FOX HILL ISLAND UNIT 2

Subject: W.O. 2555-02  
Jersey Central Power and Light Company  
Three Mile Island Nuclear Station Unit No. 2  
Transmittal of Field Change Request (FCR)  
and Associated Documents

FCR No. 188

ENGINEERING INSTRUCTION NUMBER-30 ELECTROMATIC RELAY  
VALVE LEVER MODIFICATION

SECTION B-B

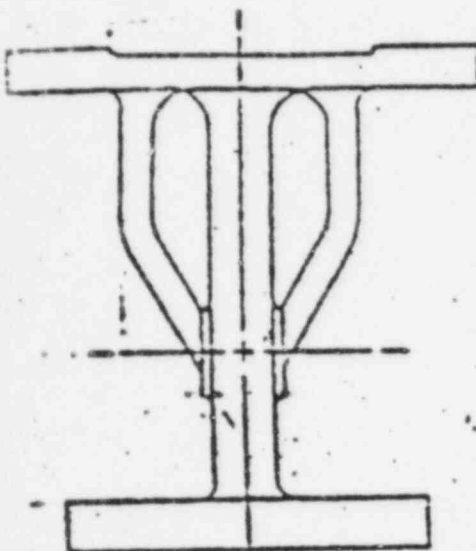
1. Measure the width of lever. If greater than 1-51/64, the spotfacing is required. Spotface when required around each lever pin hole as shown in view C providing the 1-51/64 width dimension.
2. Enlarge lever pin holes per section B-B. Centerline of holes to be perpendicular to surfaces 3.

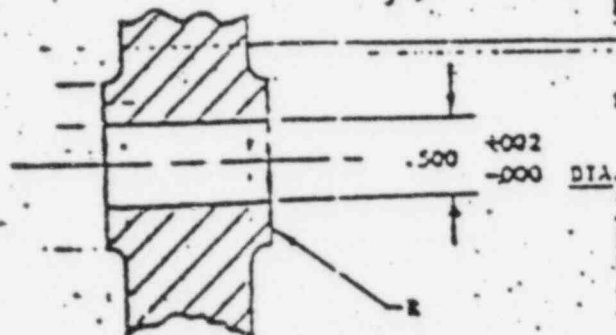
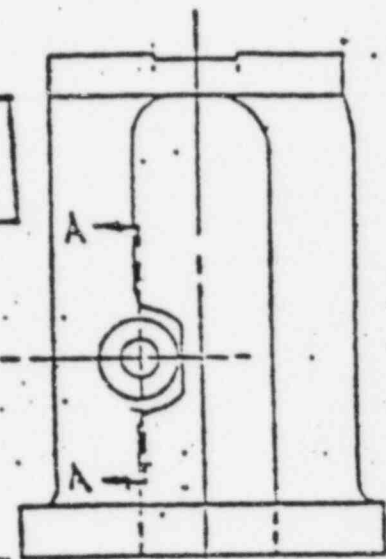
1. Enlarge hole as shown. centerline of hole to be perpendicular to surface R.

Figure 1

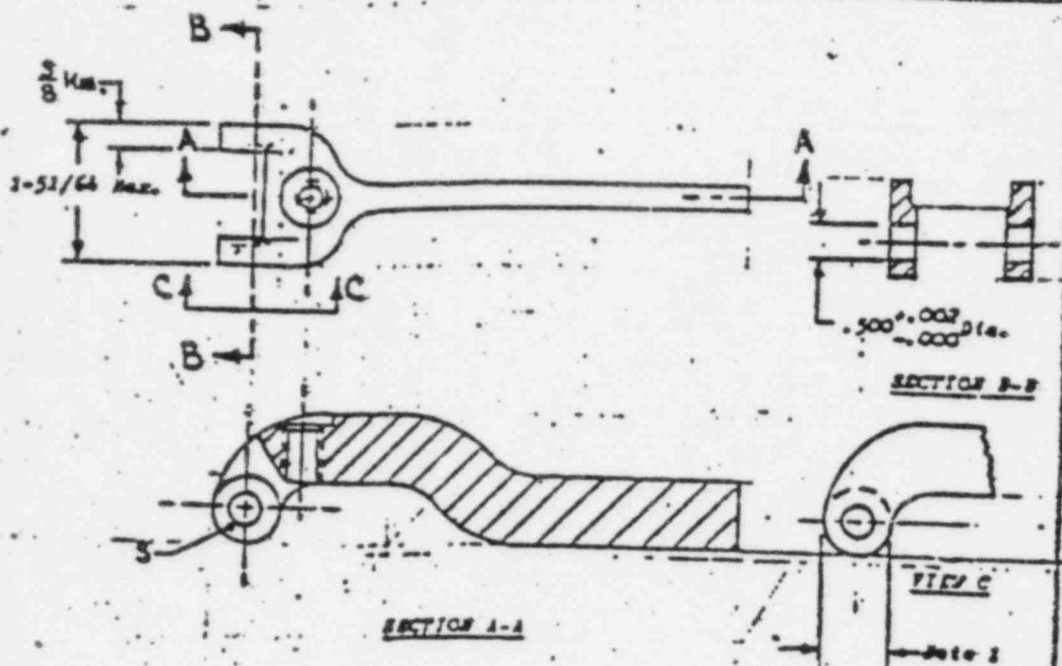
1. Measure the width of lever. If greater than 1-51/64, the spotfacing is required. Spotface when required around each lever pin hole as shown in view C providing the 1-51/64 width dimension.
2. Enlarge lever pin holes per section B-B. Centerline of holes to be perpendicular to surface S.

FIGURE 2

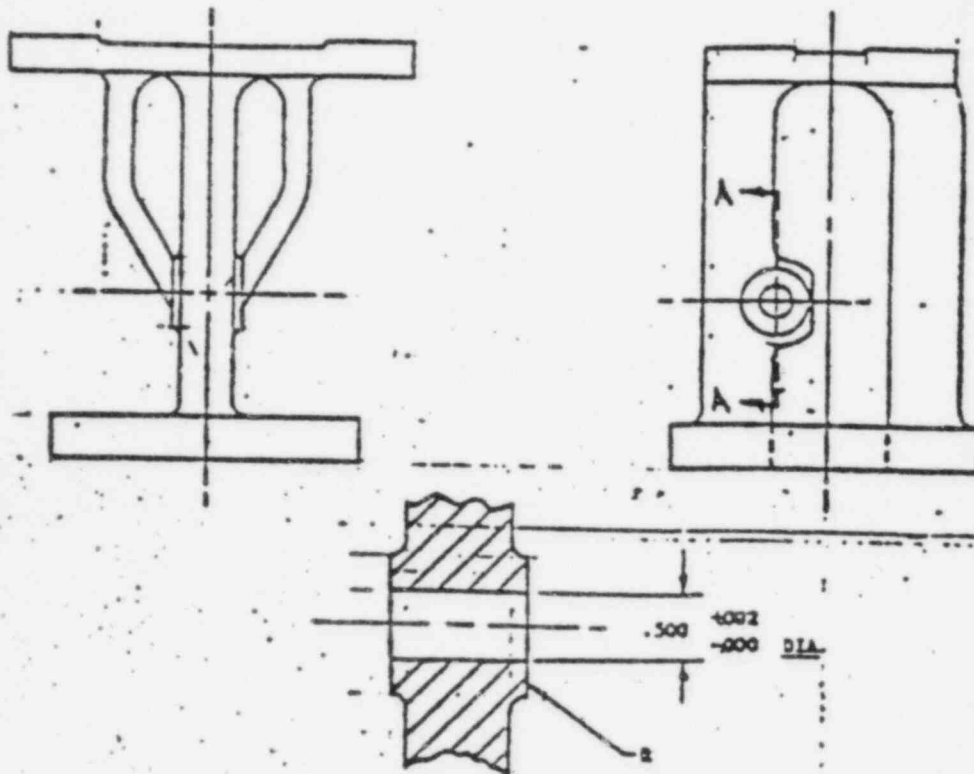
2. Enlarge hole as shown. Centerline of hole to be perpendicular to surface 2.

Figure 4

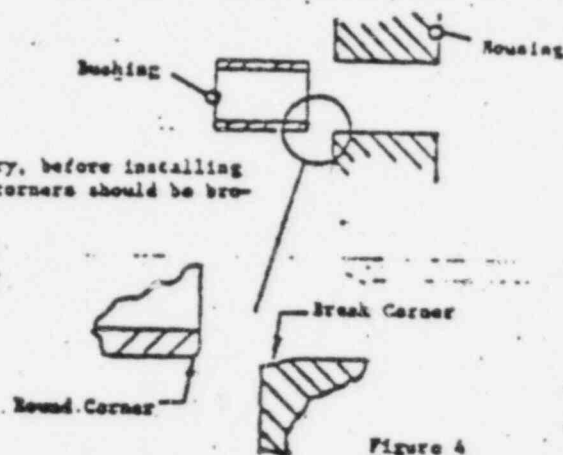
Note:  
For ease of entry, before installing  
bushing, sharp corners should be broken  
as shown.

Figure 5

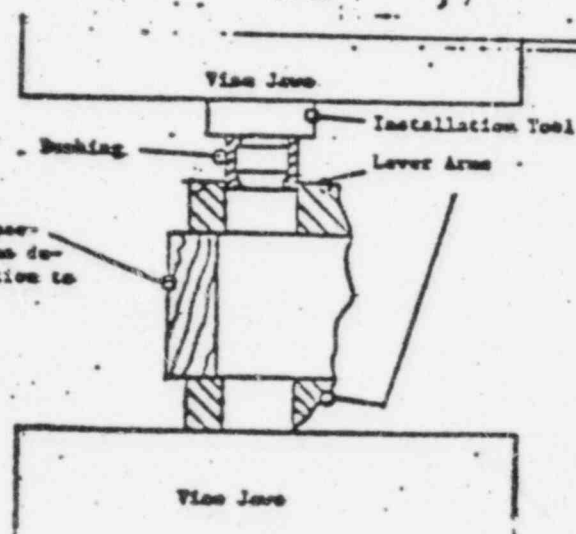
Use wood or metal spacer  
or between lever arm during  
pressing operation to  
prevent bending.

Arrangement in Vice Jaws for Pressing Bushing  
Into Lever
